PROJECT: VT RT 9, BRIDGE NO. 11
TOWN OF WOODFORD, VT
OVER WALDOMSAC RIVER

TITLE: ERECTION PLAN ABUTMENT

REFERENCE: PROJECT NO. ER BHF 010-1 (44)

ABUTMENT CROSS FRAME
(LOOKING WEST)

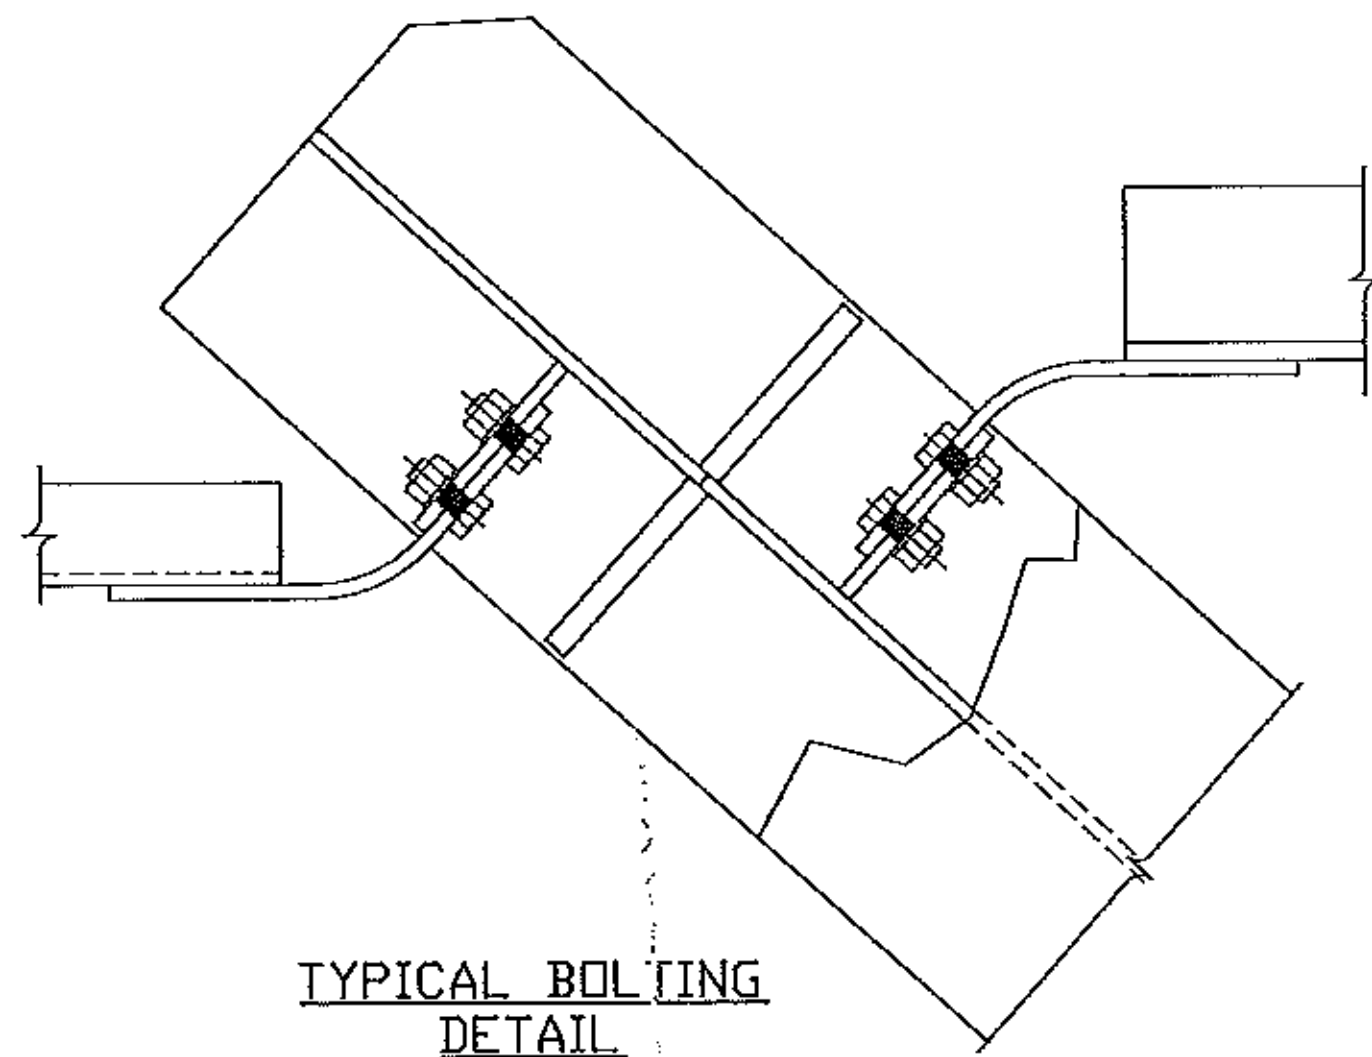
No	REVISION	DATE	PAR	VER.
1	CROSSFRAME MODIFIED	01/16/13	BR	GG

Vermont Agency of Transportation
RECEIVED
CK'D BY M.E.M. OK'D BY C.W.M.
Jan. 29, 2013
RESUBMIT APPROVED AS NOTED ✓
BY C. CARLSON DATE 01-29-2013
